ADDENDUM 2

PROJECT: Eugene School District 4J
Chinese Immersion Program Site & Building Renovation
at Kennedy Middle School (202014)
Eugene, Oregon

DATE: February 11, 2021

RE: Changes, Revisions, Clarifications and Additions

SHEET
C3.1
© COPYRIGHT 2021 by TBG Architects + Planners

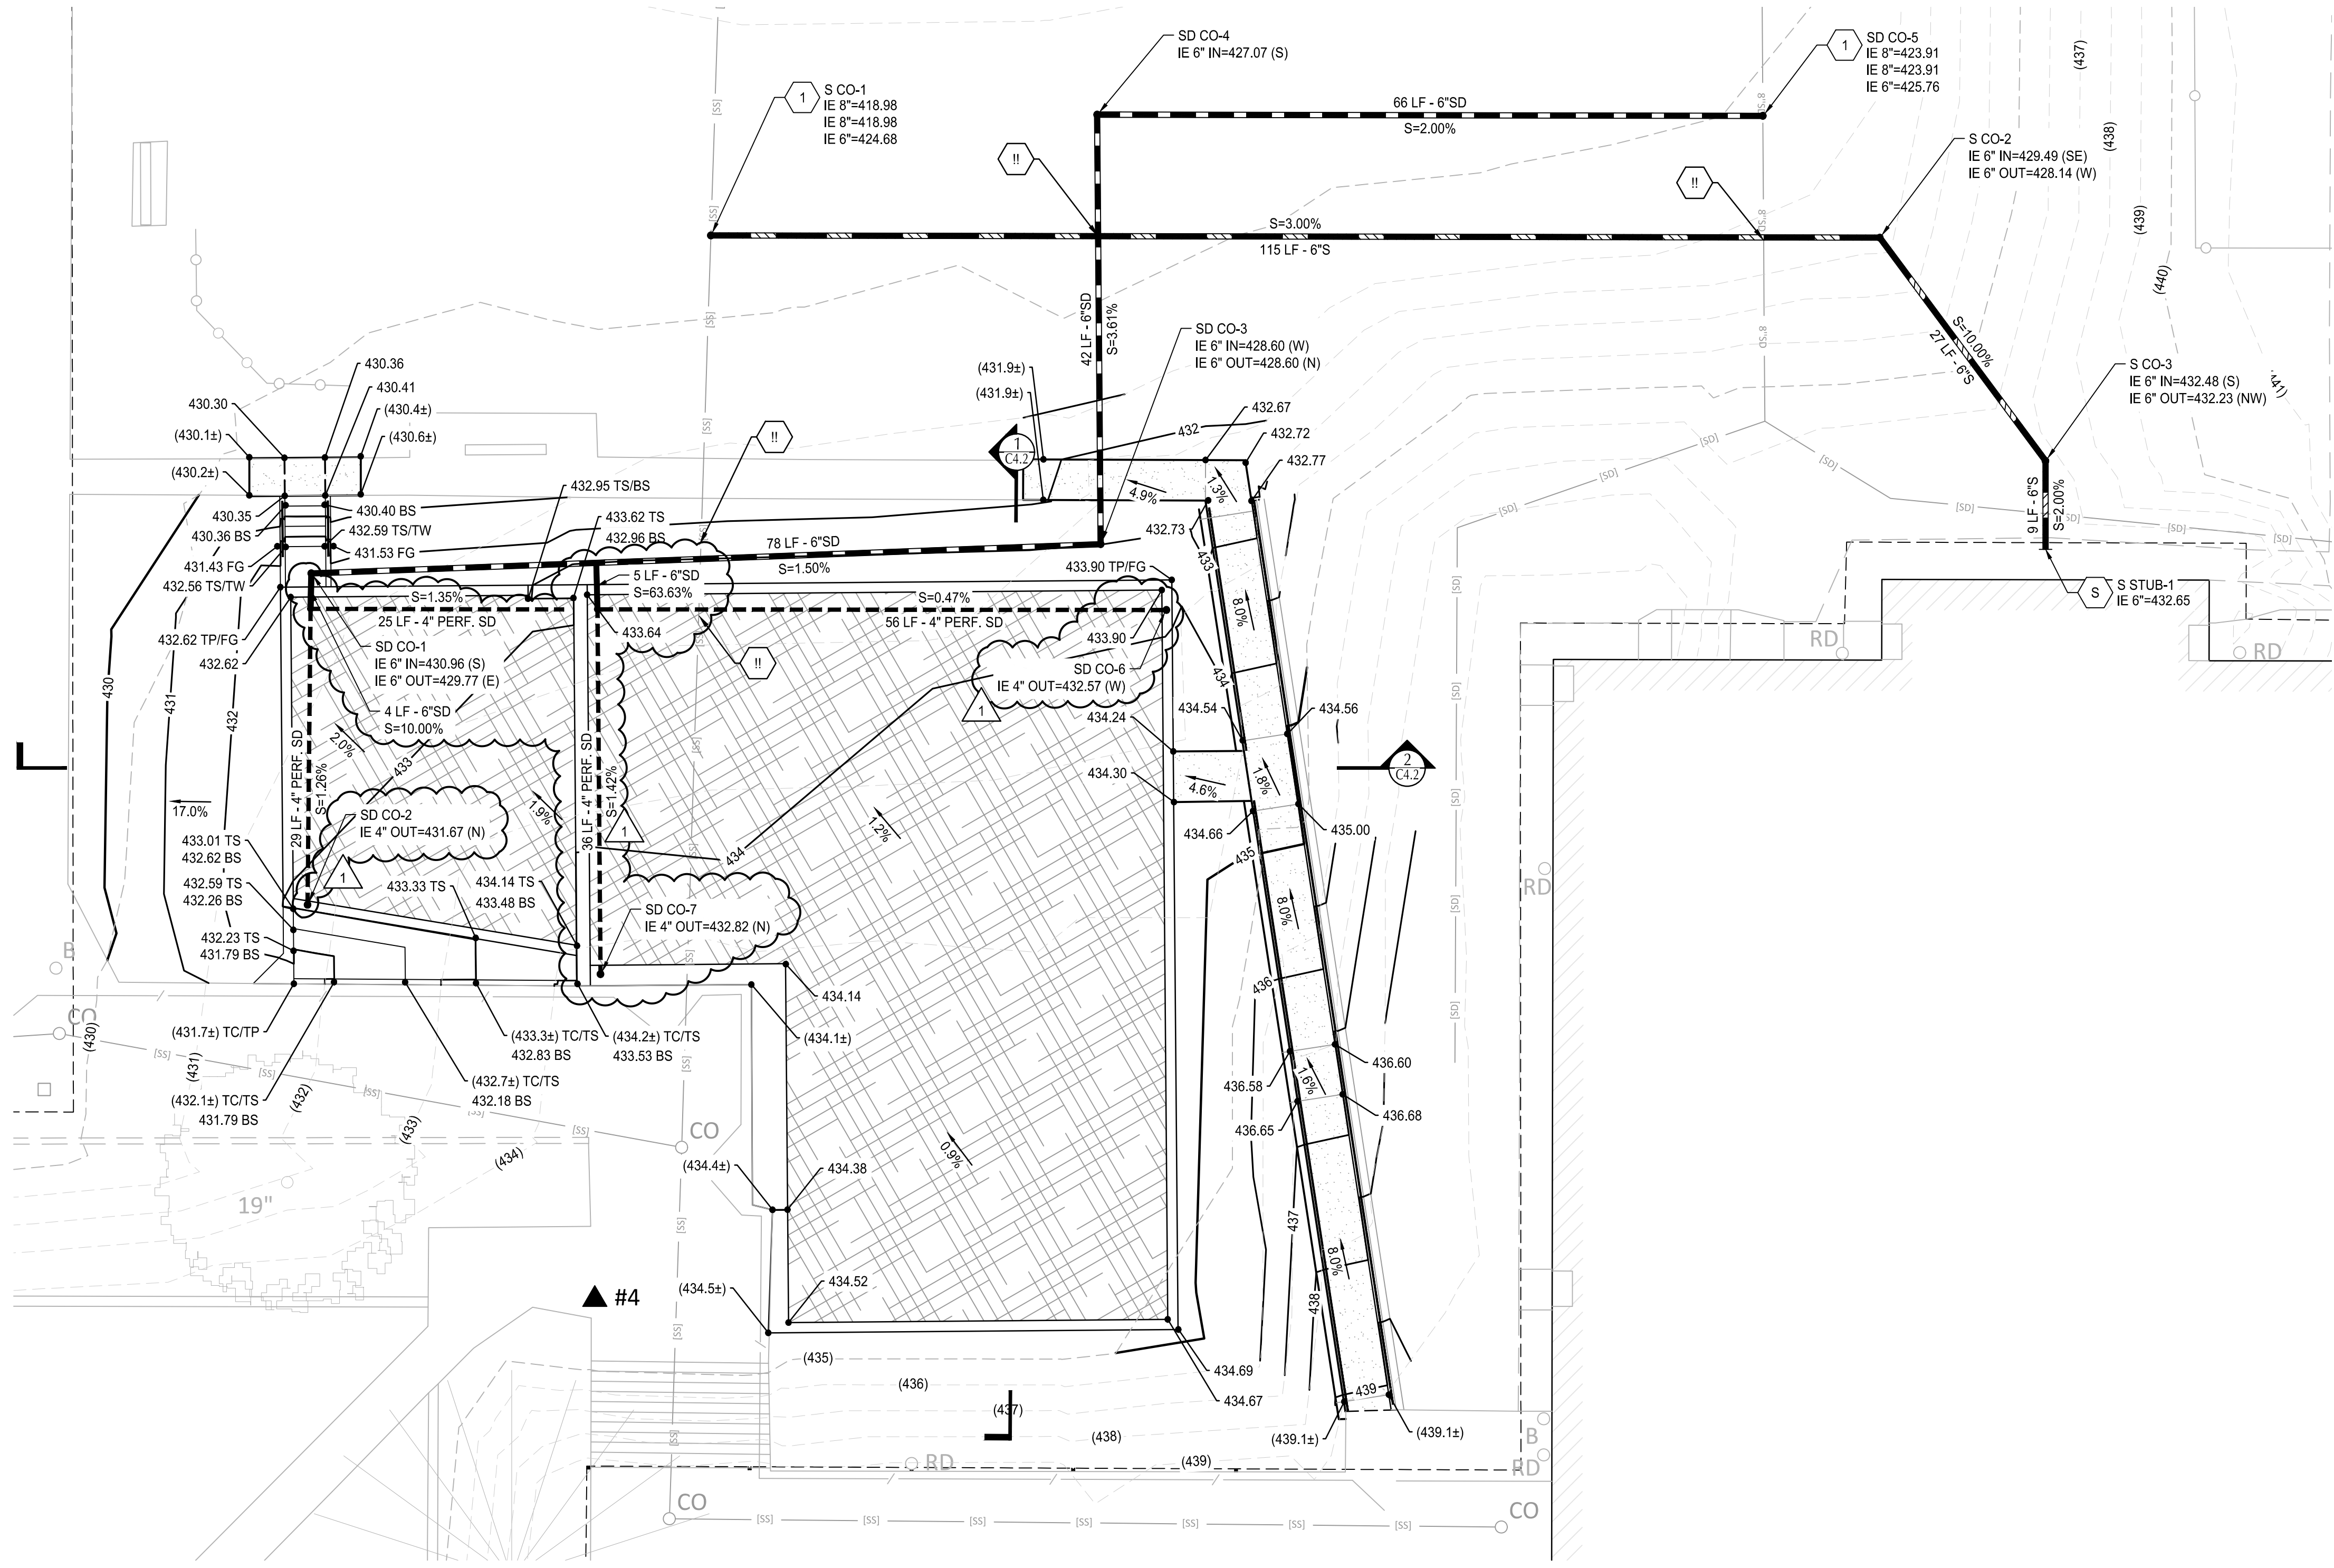
- Item 13: Reference Sheet C3.1 – SITE LAYOUT & PAVING PLAN dated January 27, 2021: Delete and replace with attached Sheet C3.1 - SITE LAYOUT & PAVING PLAN with revisions dated February 10, 2021.

SHEET
C4.1
 © COPYRIGHT 2021 by TBG Architects + Planners

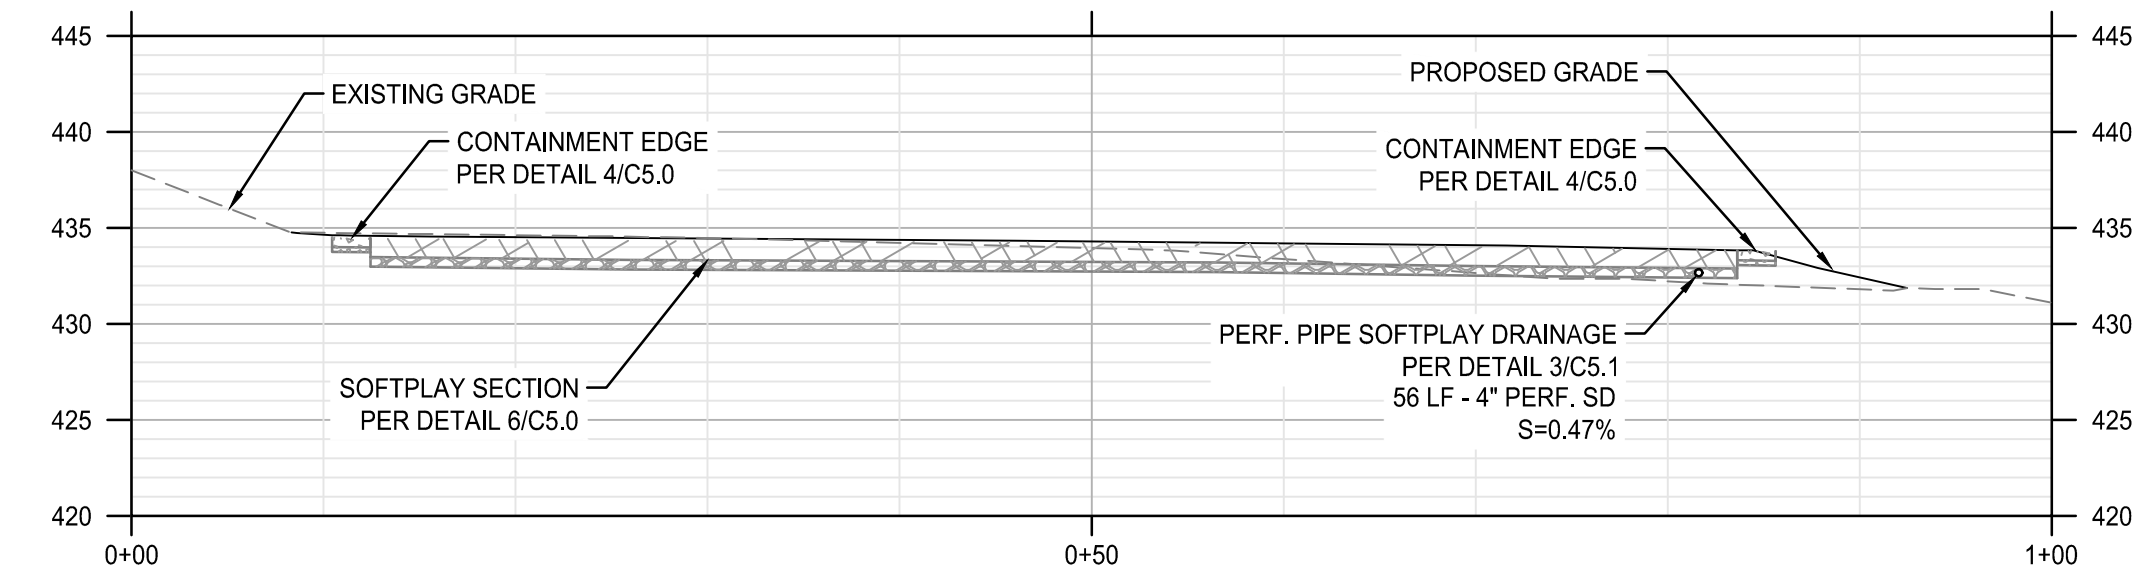
- Item 14: Reference Sheet C4.1 – GRADING & UTILITY PLAN dated January 27, 2021: Delete and replace with attached Sheet C4.1 – GRADING & UTILITY PLAN with revisions dated February 10, 2021.

SHEET
C4.2
© COPYRIGHT 2021 by TBG Architects + Planners

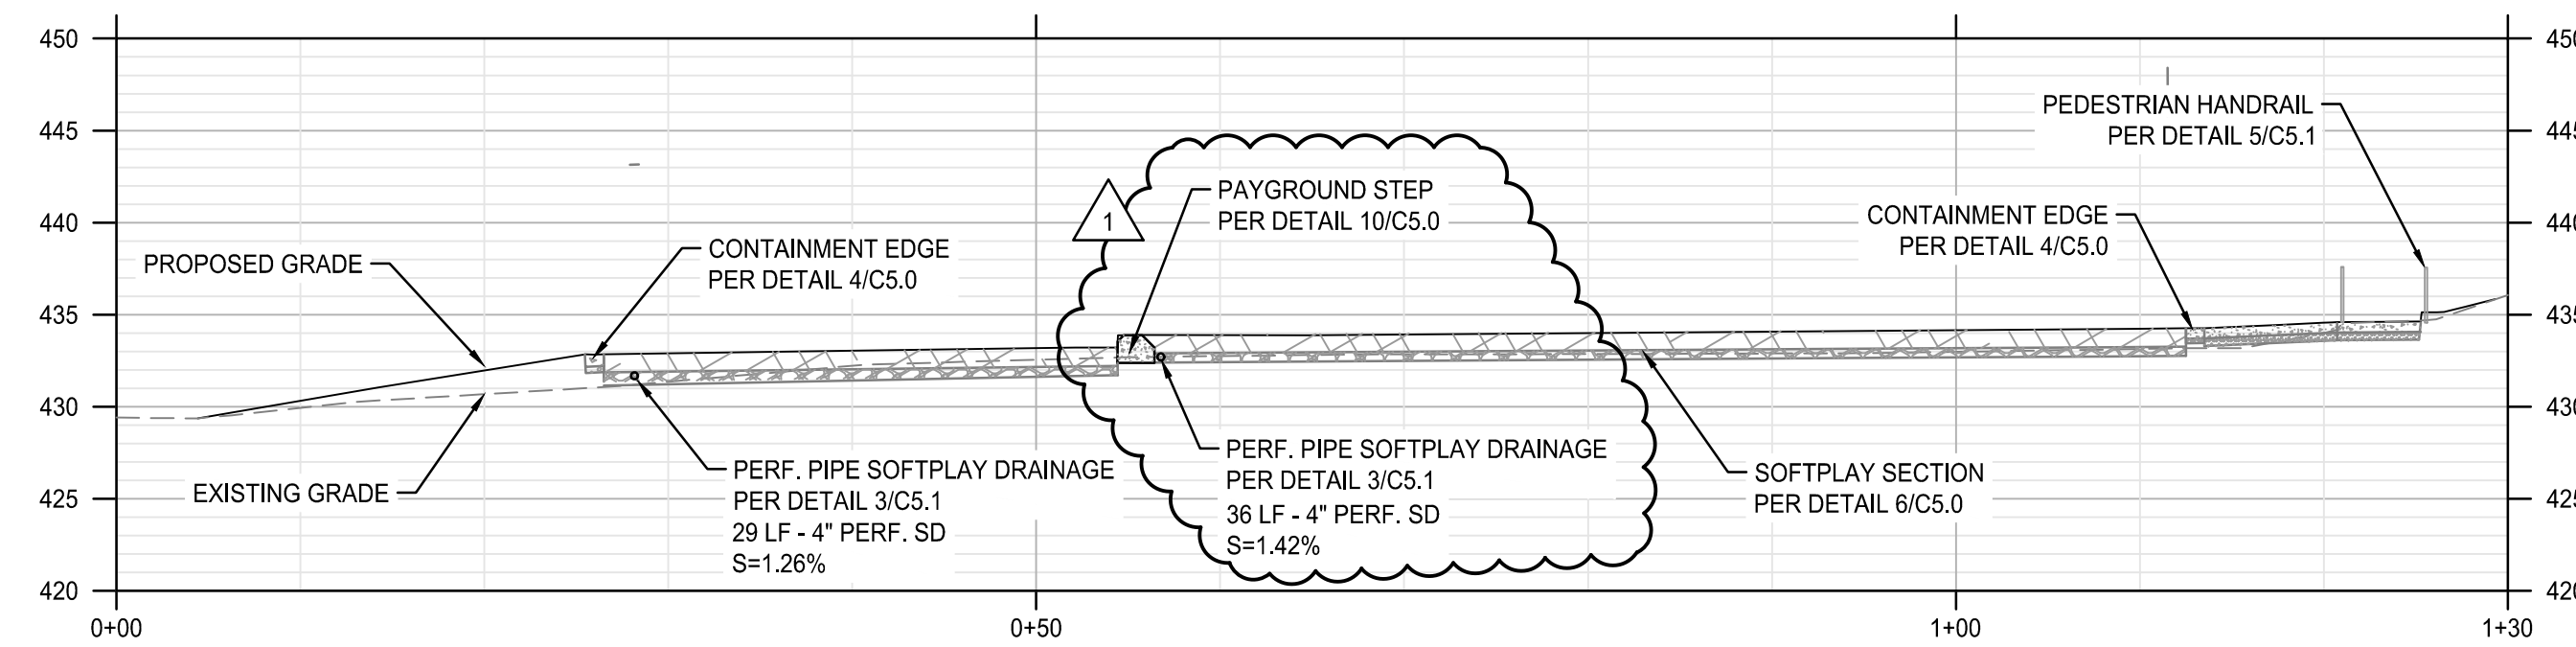
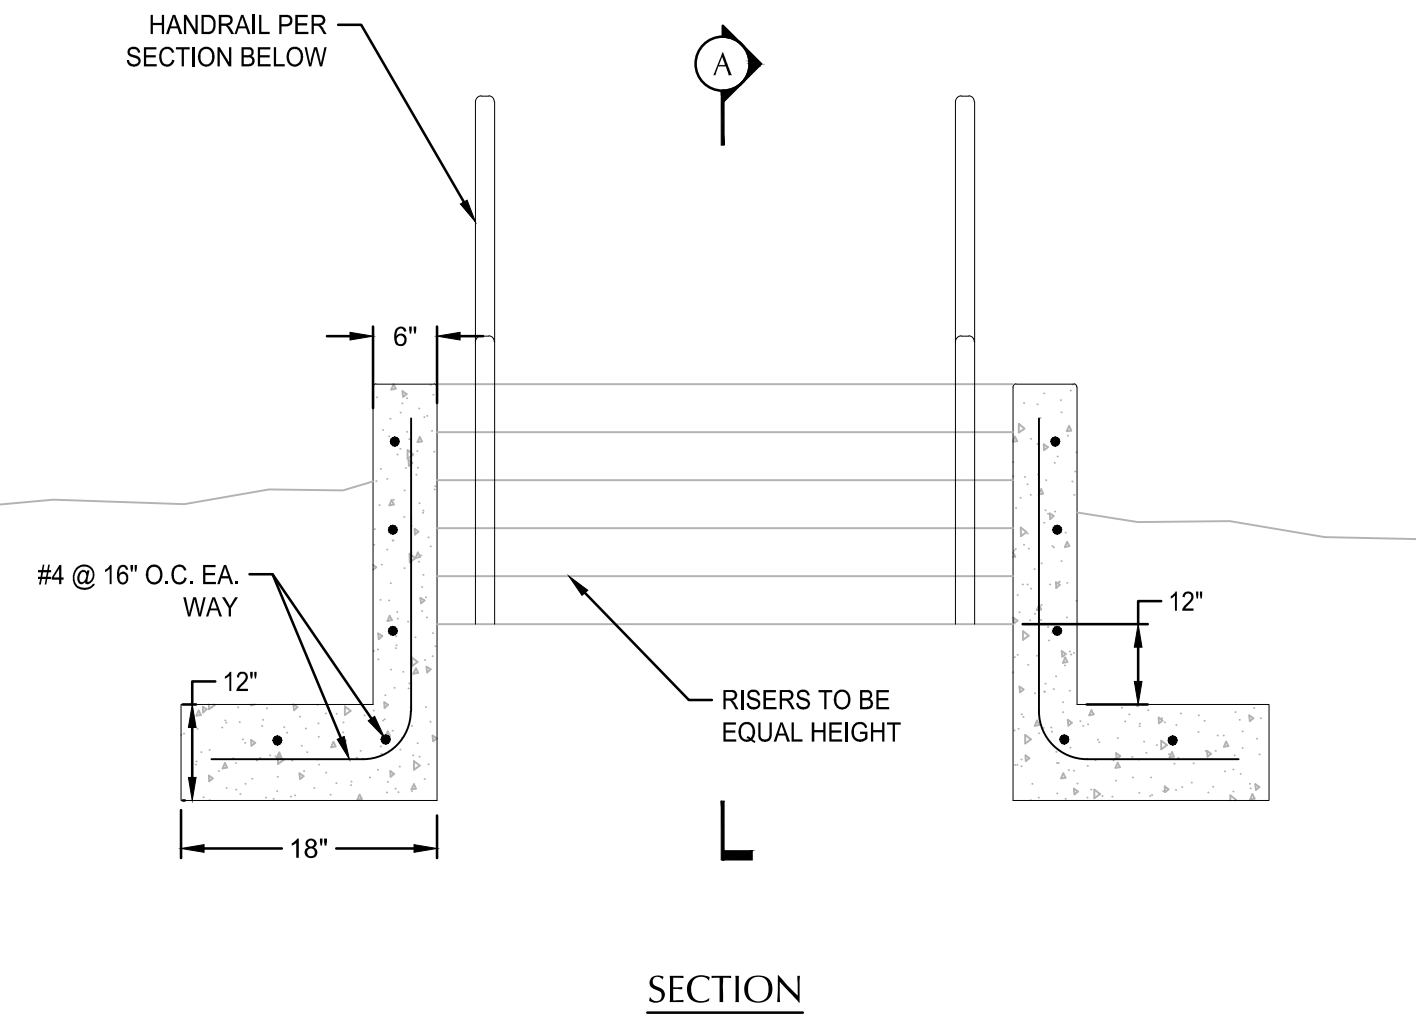
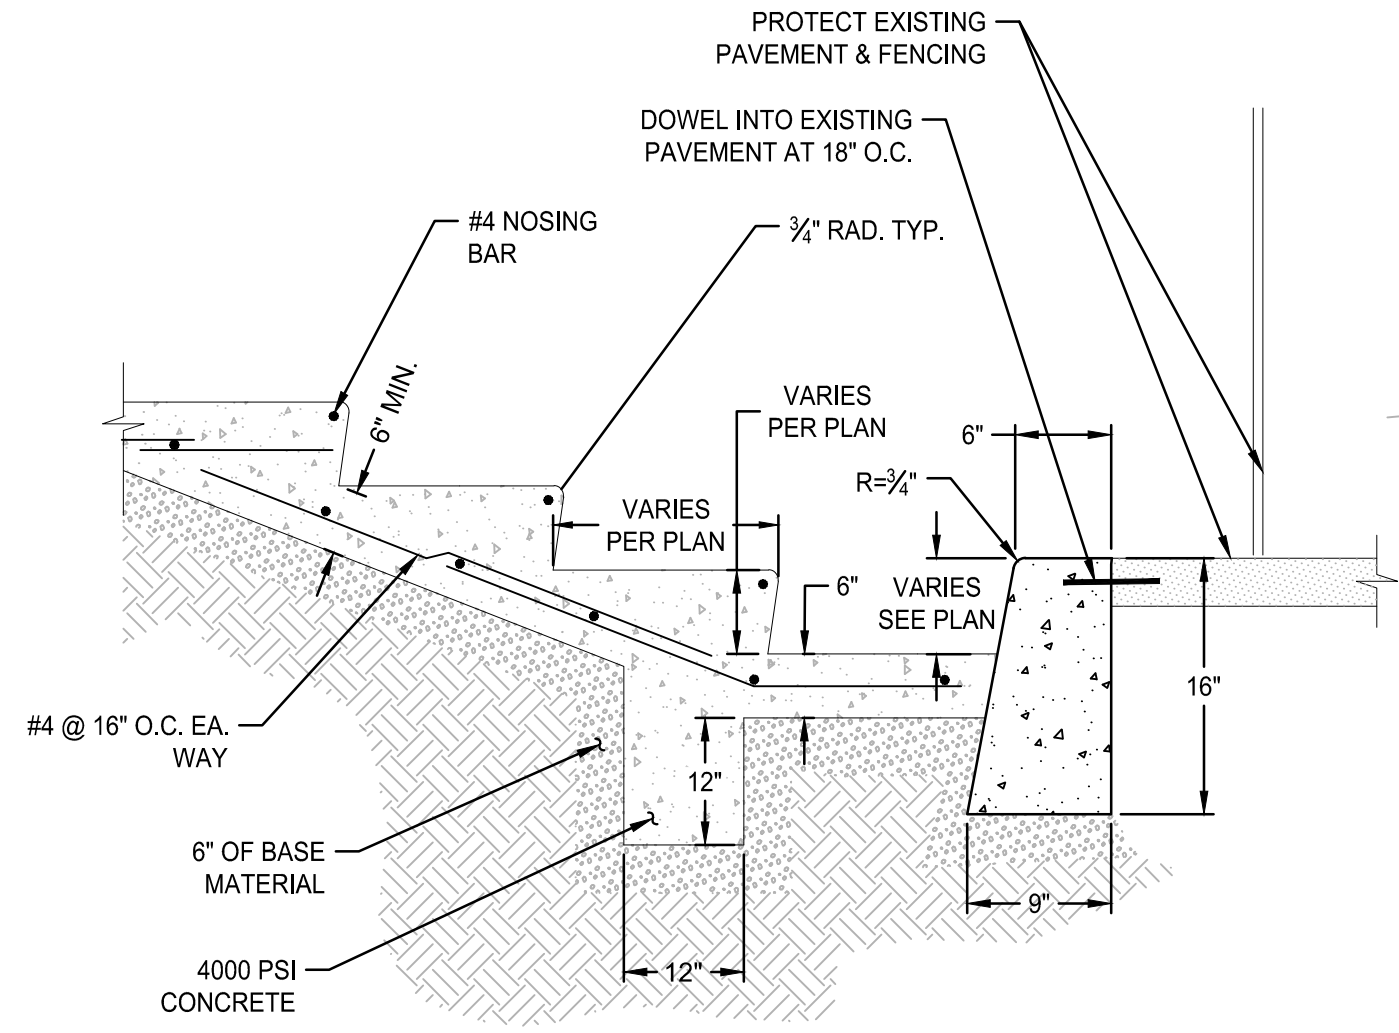
- Item 15: Reference Sheet C4.2 – GRADING & UTILITY PLAN dated January 27, 2021: Delete and replace with attached Sheet C4.2 – GRADING & UTILITY PLAN with revisions dated February 10, 2021.
